Retarder Accumulator Bracket Failure

Foretravel has become aware of an issue where a weld on the transmission retarder accumulator mounting bracket may fail due to bracket damage or fatigue. The only **affected coaches are year model 1998 through 2007 with 450 or 500 hp Cummins M11 or ISM engines** having the retarder accumulator mounted to the engine bell housing.

Bracket and Solenoid pieces dragging under coach. Also shows location of bracket attachment location above

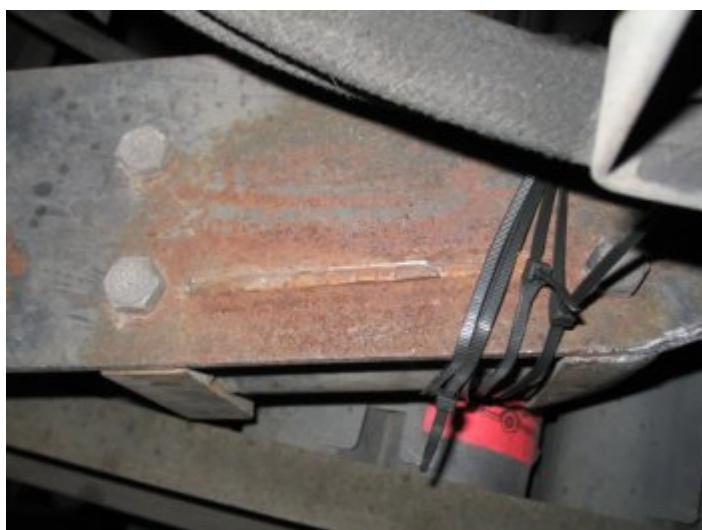
You should be able to see how easy this would be able to spot via inspection.
